REMARKS

AMENDMENT TO THE DRAWINGS:

TRW(ASG)-6052

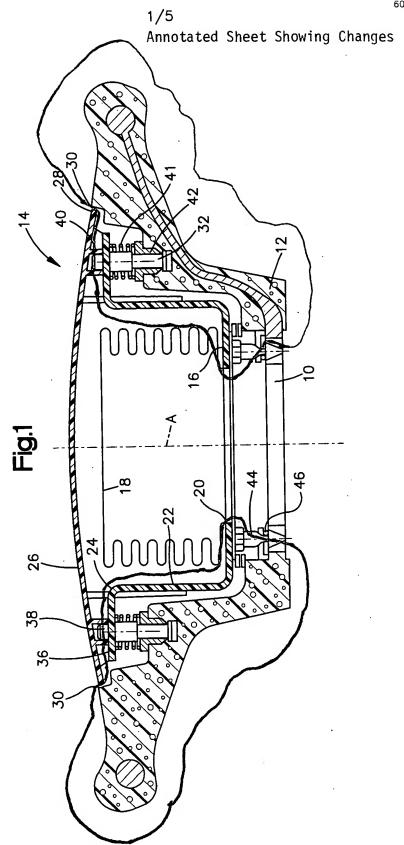
The attached sheets of drawings include changes to Figs.

1, 2, 4a, 4b, and 5. The shading for plastic for the housing

(16) has been shown in Figs. 1, 2, 4a, 4b, and 5. The shading

for foam for the foam casing (12) has been shown in Figs. 1

and 2. No new matter has been added. Further, reference

numerals 62 and 64 have not been added to Fig. 1 because the

specification does not support such an amendment.
